Technical Bulletin

Bulletin Number: 501 Revision Number: R-02

SUBJECT: REAR CONDENSATION PLATE

MODELS AFFECTED: E-Models and DMV's

Figure 1

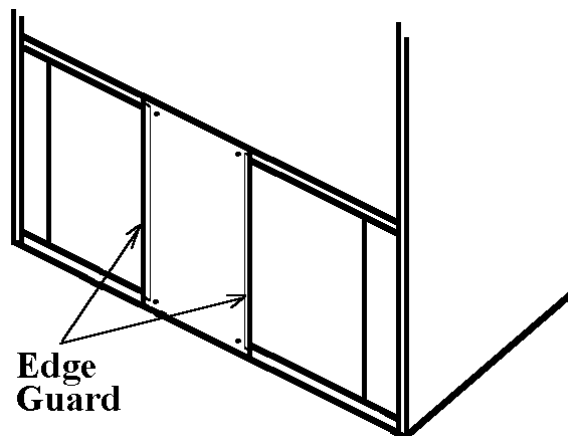
1. Loosen the four screws that secure the metal Rear Condensation Plate to the back of the vender.
2. Carefully snap the trim over the two vertical edges of the metal condensation plate. See figure 1 below.
3. Tighten the four screws loosened in step 1.

Important: *Installing the trim as instructed will secure the trim between the plate and the frame of the vender.*
